SUBJECT: Submits response to 970516 telcon RAI re restart following repair of weld overlay. Calculation re size of overlay, encl.

May 19, 1997
NMP1L 1222

RE: Nine Mile Point Unit 1
 Docket No. 50-220
 DPR-63

Subject: *Generic Letter (GL) 88-01, "NRC Position on IGSCC in BWR Austenitic
 Stainless Steel Piping"*

FIGURE 1

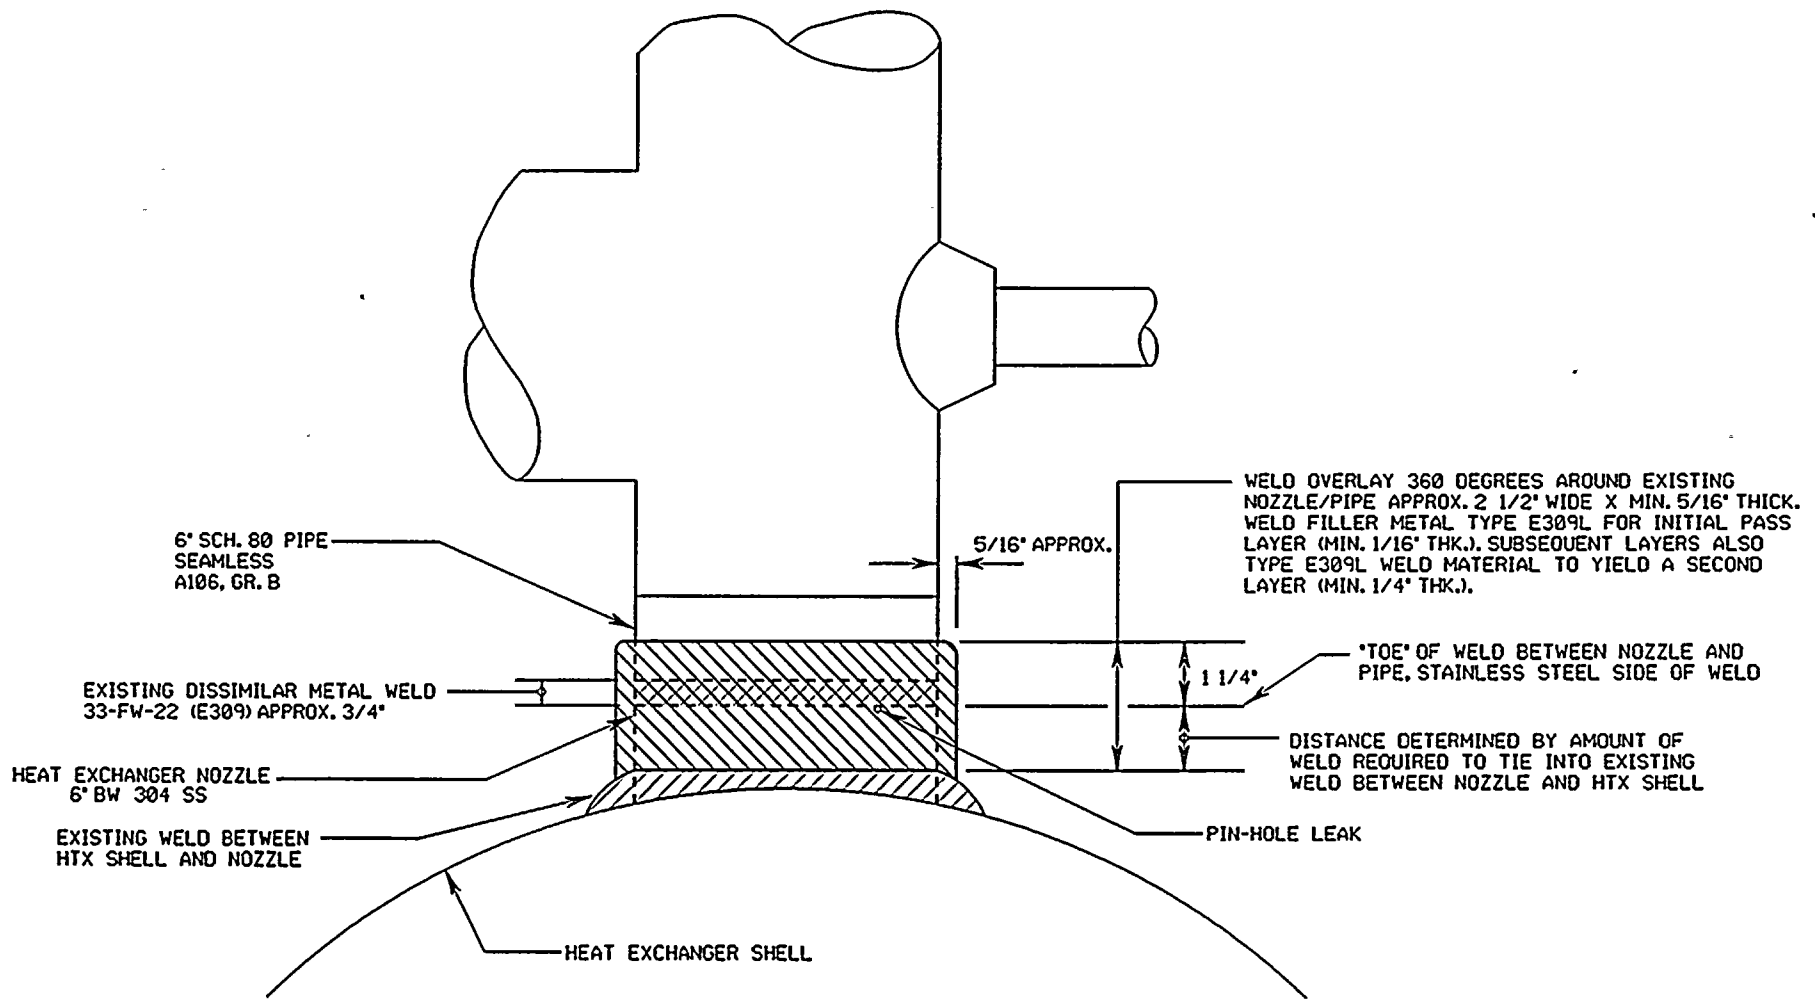
- (f)(1) The Code Case requires that the full thickness length extends "axially at least $0.75 \sqrt{Rt}$ beyond each end of the observed flaws where R and t are the outer radius and nominal wall thickness of the pipe". Because of physical restrictions, the overlay was extended as far as possible, until it butted up to the nozzle to heat exchanger shell weld. This resulted in less than a 0.25 inch reduction of the weld overlay length on the stainless steel end of the weld (calculated length, is 1.25 inches, achieved length is approximately 1 inch). Full overlay length was achieved on the opposite side of the crack tips.

- (c) The performance of a liquid penetrant examination prior to the deposition of weld reinforcement was not performed because the pinhole is greater than 1/16" which would require the complete overlay defined in c(2) to be performed. Therefore, a weld overlay was performed in accordance with c(2). The area to be reinforced by overlay was first prepared by application of an initial weld

layer which was then examined as required by item (d) of the Code Case. The application of the initial layer effectively seals any potential indications in the overlaid area.

- (k) Pipe supports near the repair area (primarily spring hangers) did not receive a VT-3. Because of the relatively small size of the overlay, no notable change in spring hanger position occurred. These pipe supports were marked and monitored for any relative change in spring setting from the application of the weld overlay. No recordable changes occurred. Because this is a non-ASME XI boundary, these pipe supports have not been visually preservice examined. No physical anomalies in the pipe supports were observed during the comparison in spring support settings.

A diagram of the overlay repair and a description of the materials being used are provided in enclosed Figure 1. The analysis used to determine the size of the overlay is included as Attachment 1.
